Proposal #15: 1000-13-76, WISC 2023585
Highway Lighting 2023 SE Region
Various Highways
Various Highways
Milwaukee County

This is Addendum No. 01, which provides for the following:

ADDENDUM NO. 01

1000-13-76

POWER WIREWAY
TYP ALL TUNNELS

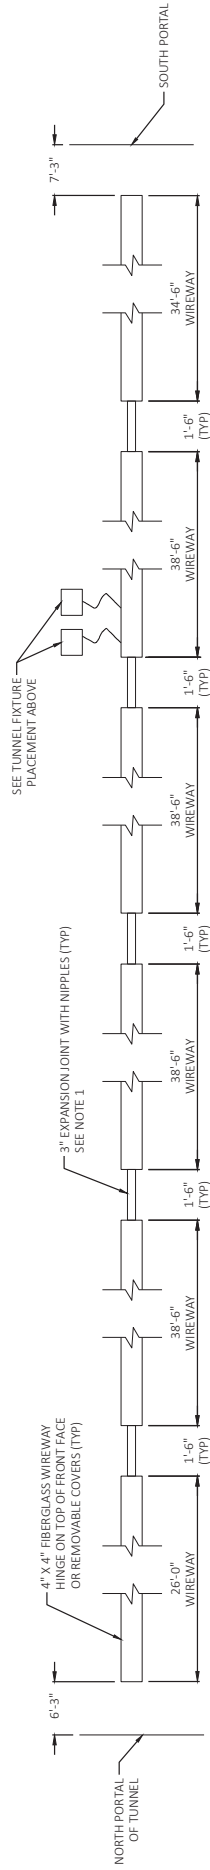
Added Plan Sheets	
Plan Sheet	Plan Sheet Title (brief description of why sheet was added)
33A	Lighting Plan sheet describing installation of Wireway Fiberglass 4-Inch x 4-Inch and line diagram for luminance photometer
33B	Lighting Plan sheet showing line diagram for Luminance photometer
88A	Miscellaneous Quantity sheet To add quantity for items Wireway Fiberglass 4-Inch x 4-Inch, Item number SPV.0090.1004, Concrete Control Cabinet Bases Type 30L, Item number 654.0230, Electrical Service Main Lugs Only Meter Pedestal (HL-40-KI), Item number 656.0401.1000, and Lighting Control Cabinets 240/480 30-Inch, Item number 659.2230.

- 1. 3-INCH GALVANIZED STEEL EXPANSION JOINT SUITABLE FOR 1/2" EXPANSION AND 3/4" DIFFERENTIAL SETTING. COST IS INCIDENTAL TO WIREWAY, TYPICAL S. LOCATIONS. CENTER EXPANSION JOINT ON WALL CONSTRUCTION JOINT
- 2. 3/4" LIQUIDTIGHT FLEXIBLE METALLIC CONDUIT (LDMC) WITH 2#10, GND TO ALL FIXTURES ON THE TOP AND LOWER LEVEL WIRE TO BE THINW/THIN.

LIGHTING CONTROLS BLOCK DIAGRAM
HOWELL TUNNELS

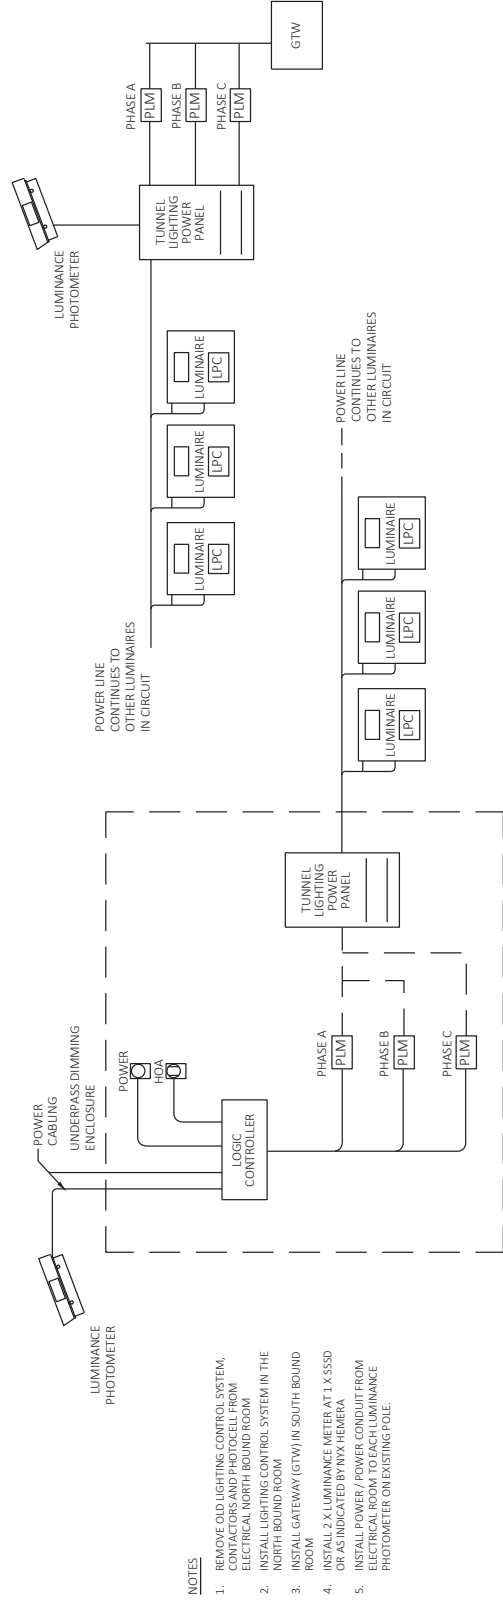
- 1. REMOVE OLD LIGHTING CONTROL SYSTEM, CONTACTORS AND PHOTOCELL FROM ELECTRICAL NORTH BOUND ROOM
- 2. INSTALL LIGHTING CONTROL SYSTEM IN THE NORTH BOUND ROOM
- 3. INSTALL GATEWAY (GTW) IN SOUTH BOUND ROOM
- 4. INSTALL 2 X LUMINANCE METER AT 1 X SSSD OR AS INDICATED BY NYX HEMERA
- 5. INSTALL POWER / POWER CONDUIT FROM ELECTRICAL ROOM TO EACH LUMINANCE PHOTOMETER ON EXISTING POLE.

Addendum No. 01
 ID 1000-13-76
 Added Sheet 33B
 November 10, 2023

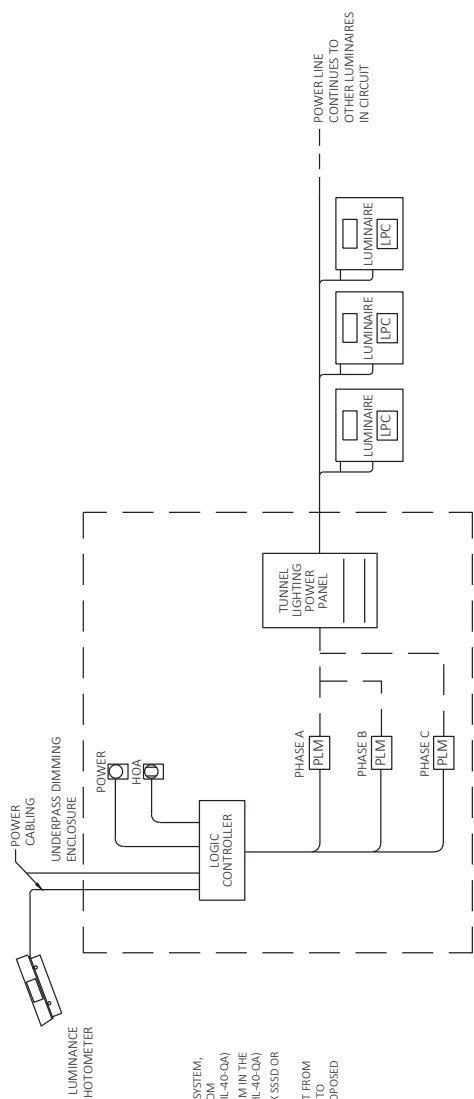
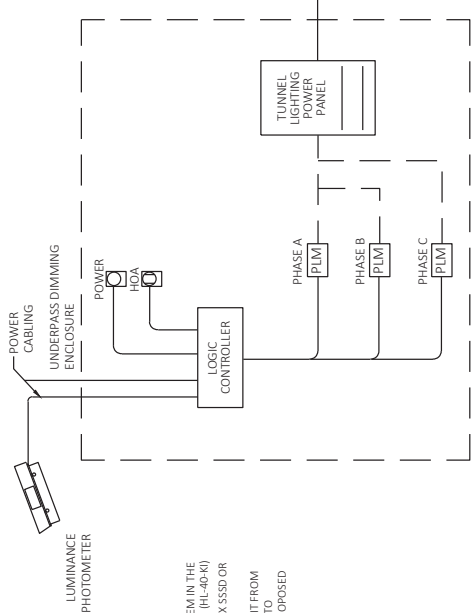
- NOTES**
1. REMOVE OLD LIGHTING CONTROL SYSTEM, CONTACTORS AND PHOTOCELL FROM EXISTING DISTRIBUTION CENTER (HL-40-QA)
 2. INSTALL LIGHTING CONTROL SYSTEM IN THE EXISTING DISTRIBUTION CENTER (HL-40-QA)
 3. INSTALL LUMINANCE METER AT 1 X 55SD OR AS INDICATED BY NYX HEMERA
 4. INSTALL POWER / POWER CONDUIT FROM DISTRIBUTION CENTER (HL-40-QA) TO LUMINANCE PHOTOMETER ON PROPOSED POLE AND FOUNDATION.

- NOTES**
1. INSTALL LIGHTING CONTROL SYSTEM IN THE PROPOSED DISTRIBUTION CENTER (HL-40-K)
 2. INSTALL LUMINANCE METER AT 1 X 55SD OR AS INDICATED BY NYX HEMERA
 3. INSTALL POWER / POWER CONDUIT FROM DISTRIBUTION CENTER (HL-40-K) TO LUMINANCE PHOTOMETER ON PROPOSED POLE AND FOUNDATION.
